ATTACHMENT 1 – Council Submission

SSDA 849, 853, 859 Pacific Highway and 2-8 Wilson Street, Chatswood

Image: Height non-compliance

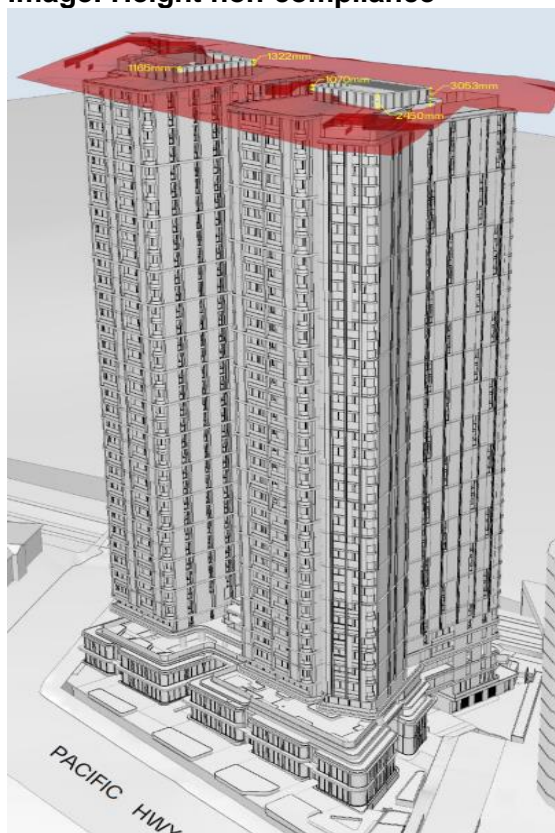
The subject SSDA proposes a total height of 120.05m or 36 storeys, being an increase of 30.05m above the recently increased 90m maximum.

The subject SSDA involves the affordable housing height bonus and then subsequent further variation. The proposed height is accompanied by WLEP CI 4.6 Variation. Based on the Housing SEPP, the affordable housing bonus results in a possible height of 117m. The SSDA therefore involves a proposed variation of 3.05m.

Image: Pacific Highway Ground level setbacks proposed in SSDA

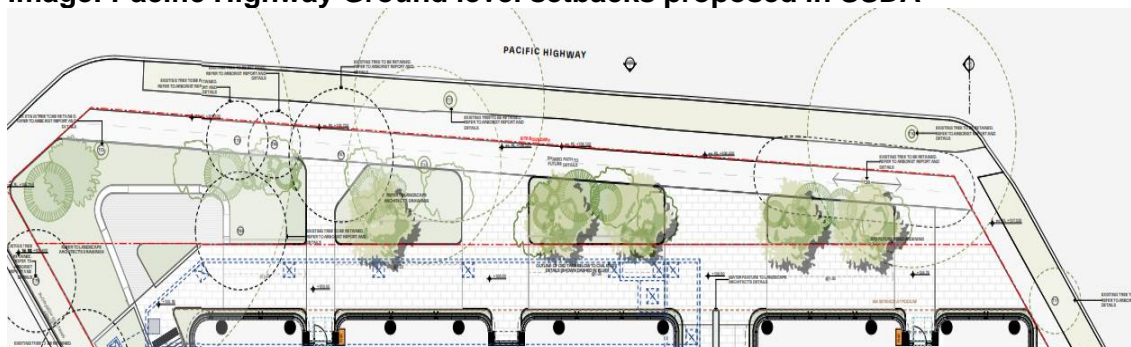
- Confirmation is required whether any of the 4m setback is required to facilitate provision of the shared pedestrian and bicycle path. This would need to be shown on plan.

- There are trees that will be affected by TfNSW requirements resulting in tree loss, and a loss of soft landscaping and canopy on the Pacific Highway frontage. This reduced green presence requires an appropriate proponent response both in terms of street trees and on-site in the front setback.

- How the design meaningfully addresses the provision of a pocket park at the Pacific Highway and O'Brien Street corner of the site.
- Plans should show how Council's vision for the Pacific Highway setback is being satisfactorily addressed based on the CBD Strategy and WDCP Part L: Place Based Plans. This discussed further below.

Image: O'Brien Street Ground level setbacks proposed in SSDA

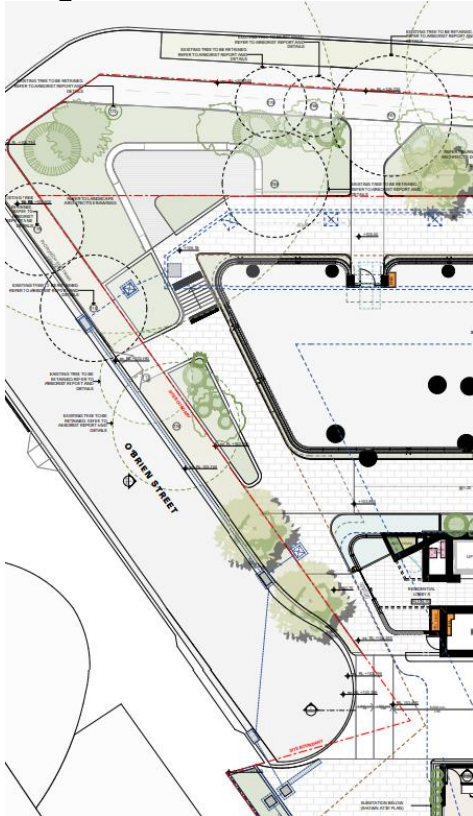
The through site link connection to the south of O'Brien Street is obstructed by the OSD and raised planter directing pedestrian traffic onto the roadway.

Left - extract from Ground Floor - Landscape Plan with Basement 01 plan overlaid.
Right - extract from AIA.

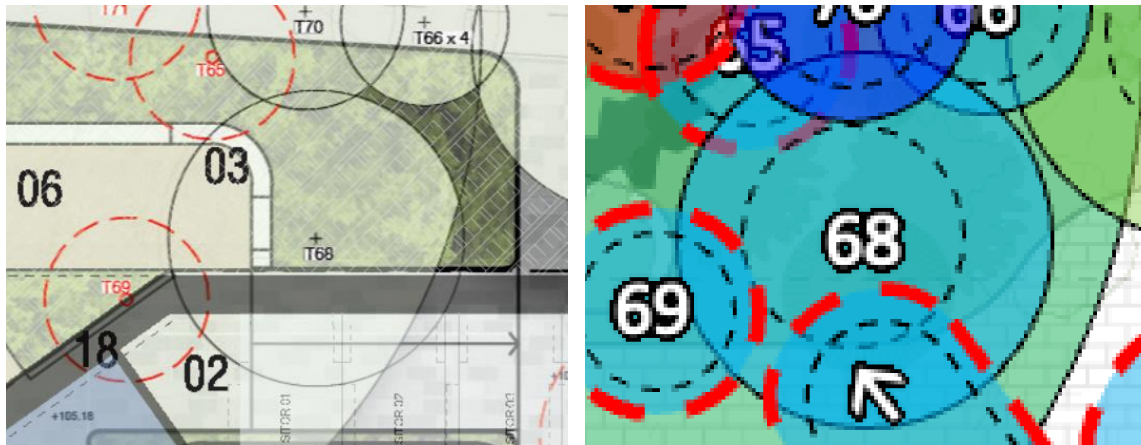
Landscape plan shows significantly greater incursion to TPZ including significant incursion to SRZ. Basement will also have major incursion into SRZ. The tree will not be retainable.

Left; extract from Ground Floor - Landscape Plan.
Right; extract from AIA.

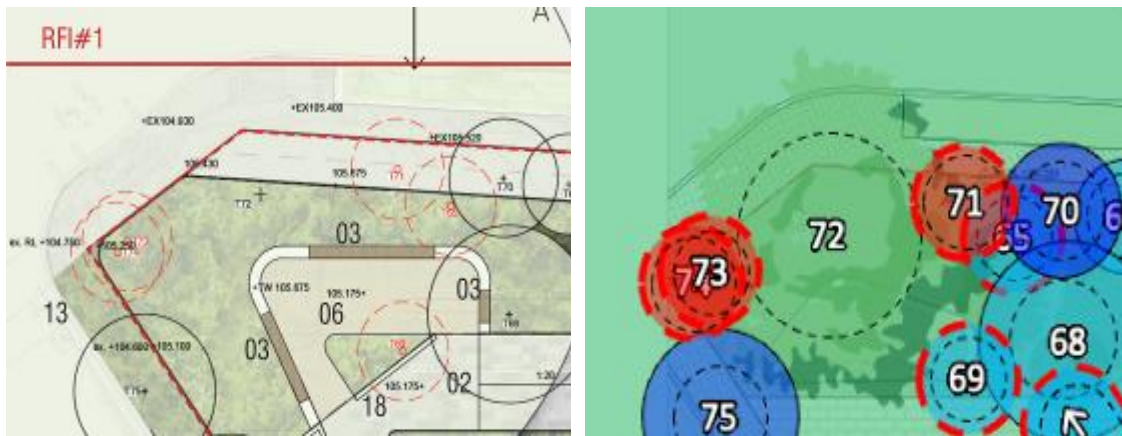
Tree T72 – *Cupressus sp.*

AIA notes a 28.1% incursion; landscape plans show shared path to be built adjacent to the trunk, and the pocket park walls and seating within the SRZ, which have not been accounted for in the AIA as it used a different landscape plan for assessment.

Image: Extract from Ground Floor Landscape Plan with Basement 01 plan overlaid.

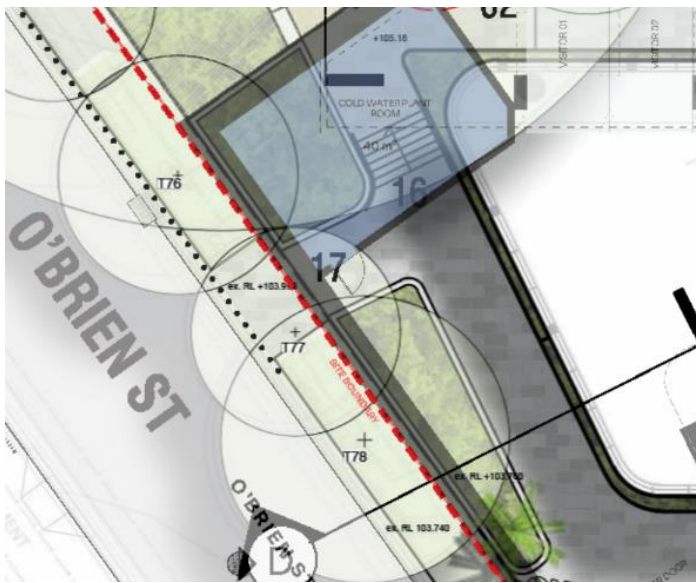
Tree T76, T77 and T78 – *Tristaniaopsis laurina*

Street trees on O'Brien Street. The AIA notes 15% and 7% incursions respectively for stormwater and paving, however does not account for basement excavation, which will have a major encroachment.

If the trees are to be retained sufficient evidence is to be provided to demonstrate the trees will be capable of surviving the impacts of the development. If the trees require removal it shall be clearly indicated on the plans.
